MCPB
Item # **15**
9/16/2010

MEMORANDUM

TO: Montgomery County Planning Board
VIA: Mark Pfefferle, Acting Chief, Environmental Planning *MP*
FROM: Marco Fuster, Senior Planner, Environmental Planning *MF*
REVIEW TYPE: Limited Amendment to Forest Conservation Plan
PLAN NAME: Long Branch Walkway-Bridge and Sidewalk
PLAN NUMBER: MR2007901
REVIEW BASIS: Chapter 22A - Forest Conservation Law
LOCATION: Long Branch Stream Valley Park, Silver Spring
APPLICANT: Department of Housing and Community Affairs (DHCA)
ENGINEER: JMT and Zimar & Associates, Inc.
DATE: September 3, 2010

**SUBJECT: Long Branch- Walkway-Bridge
Mandatory Referral No. 07901-DH&CA-1**

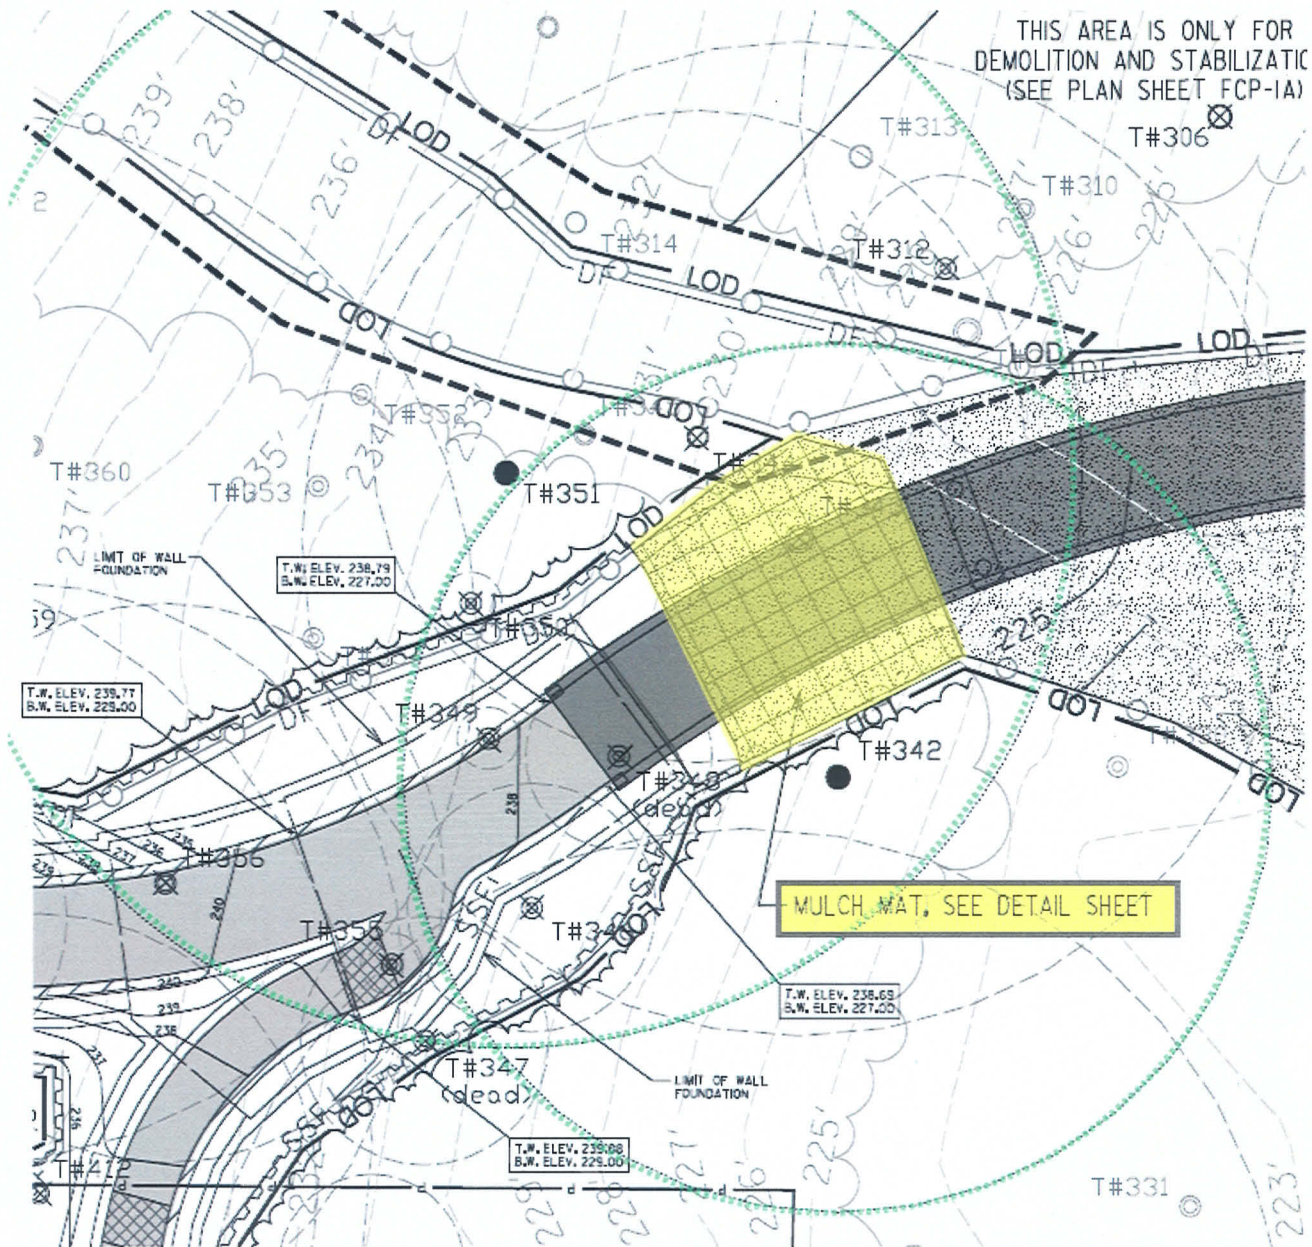
After 50% design development stage, drawings of the adjacent community center indicated a sewer man-hole in the vicinity of the proposed bridge and trail. The applicant and applicant's engineer could not detect any man holes in the area. The applicant made a special request to WSSC to field locate the man-hole in question but WSSC did not have accurate drawings of the nearly 50-year old system. WSSC did eventually find a number of the man-holes that were completely covered and marked the man-holes with vertical white markers. The newly identified features were then plotted by the applicant's engineer and included on the bridge-trail plans. One of the man-holes is located

adjacent to the south edge of bridge footprint. WSSC requested a 5-foot horizontal clearance from the bridge to the man-hole. Therefore the bridge alignment was shifted 5-6 feet north to clear the man-hole per WSSC requirements. A sketch showing the realigned bridge was forwarded to M-NCPPC staff and conceptually approved.

Proposed Alignment.

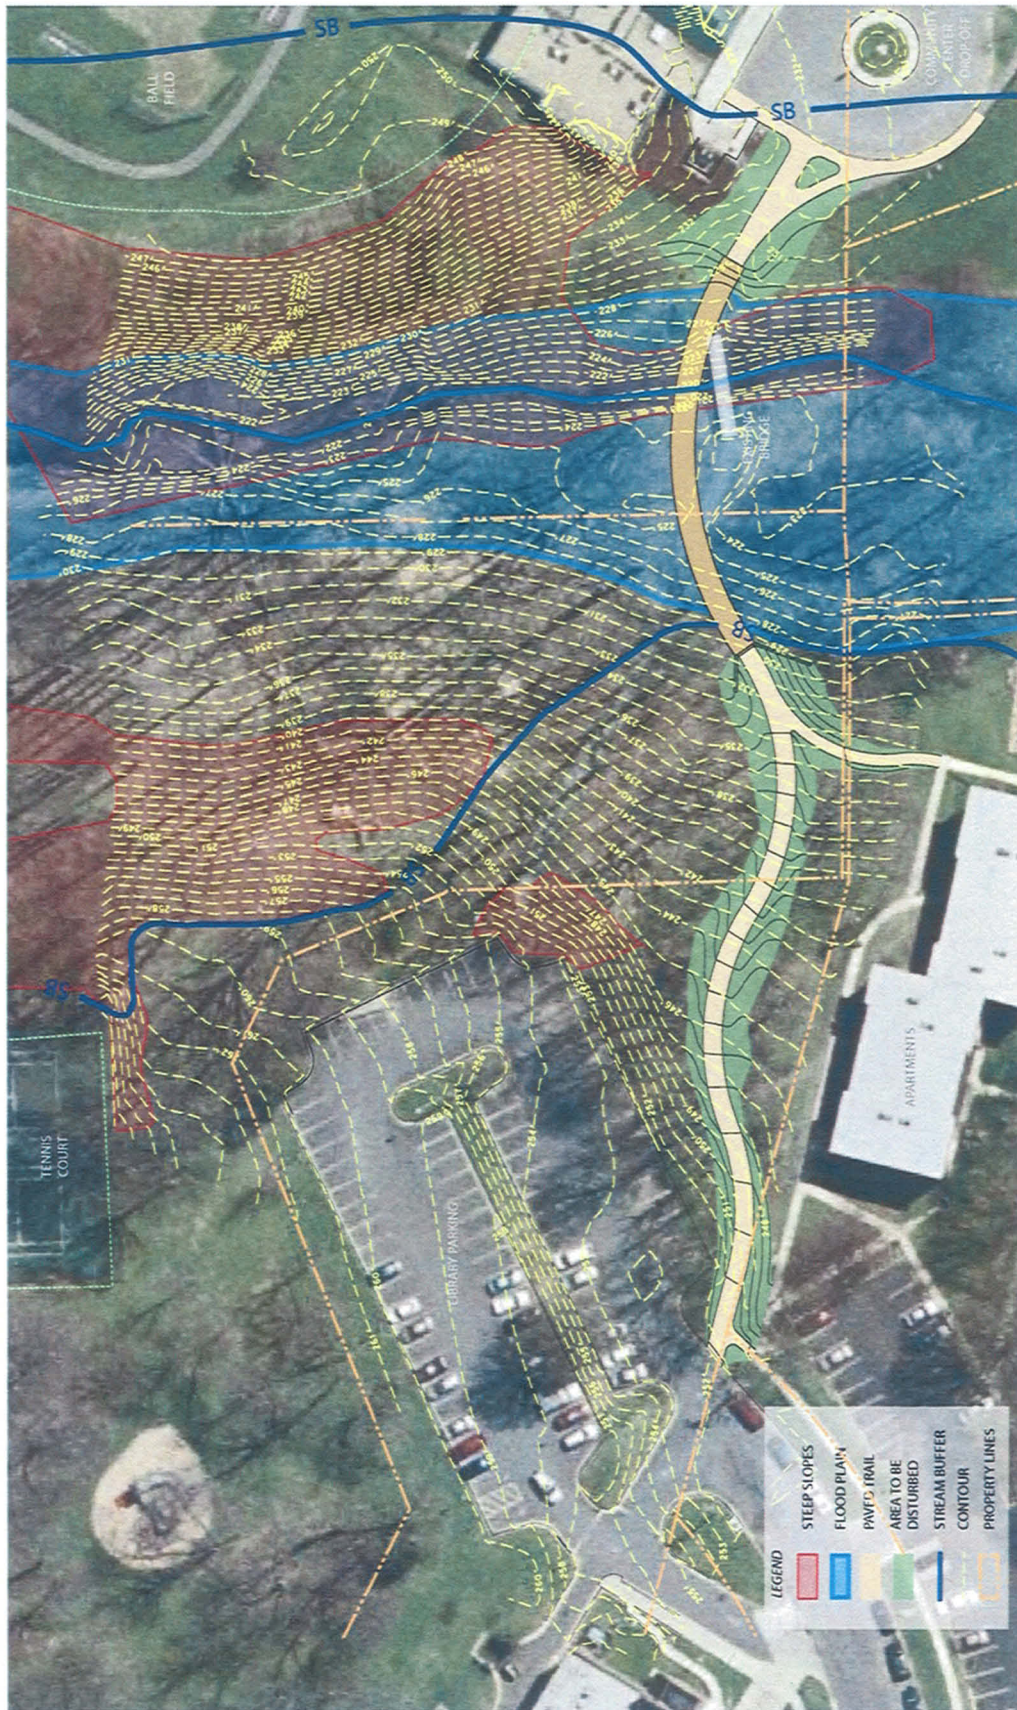
2. Trail – The trail shall be a minimum of 8 feet wide (2% maximum cross slope) with 2-foot grass shoulders (maximum 4% cross slope) on both sides unless otherwise specified by M-NCPPC staff. The trail shall be sited to minimize environmental impacts. A profile of the bridge and trail alignment, showing existing and proposed grades, shall be submitted for review and approval by M-NCPPC staff. All trees, along the bridge and trail alignment, shall be limbed up to a minimum 12-foot height to provide for free travel of both police cruisers and maintenance trucks. The trail and bridge shall be built to meet American Association of State Highway and Transportation Officials (AASHTO) as well as the Americans with Disabilities Act (ADA) standards. A striped crosswalk and curb ramp shall be provided at the trail entrances to meet the Department of Public Works and Transportation standards to connect the trail to the Long Branch Library and Community Center sidewalk. Prior to Park Permit, a Trail / Signage Plan shall be reviewed and approved by the M-NCPPC staff. Signage shall be provided as required by M-NCPPC standards, which prohibits unauthorized motor vehicles.

The 170-foot (approximate) length bridge shall be constructed as a steel stringer bridge, with steel or concrete piers, concrete abutments, and a maximum of two to four spans, unless otherwise approved by the MNCPPC. The steel stringers shall be made of weathering steel and shall be constructed from high-strength, self-weathering, low alloy, atmospheric corrosion resistant steel. The pier locations shall be adjusted accordingly to provide maximum clearance of stream banks. Pedestrian access shall be maintained as much as possible during construction, or alternative routes shall be designated. The floodplain fill soil, presently existing near the park bridge abutments, shall be removed and the existing floodplain shall be restored to its natural grade.
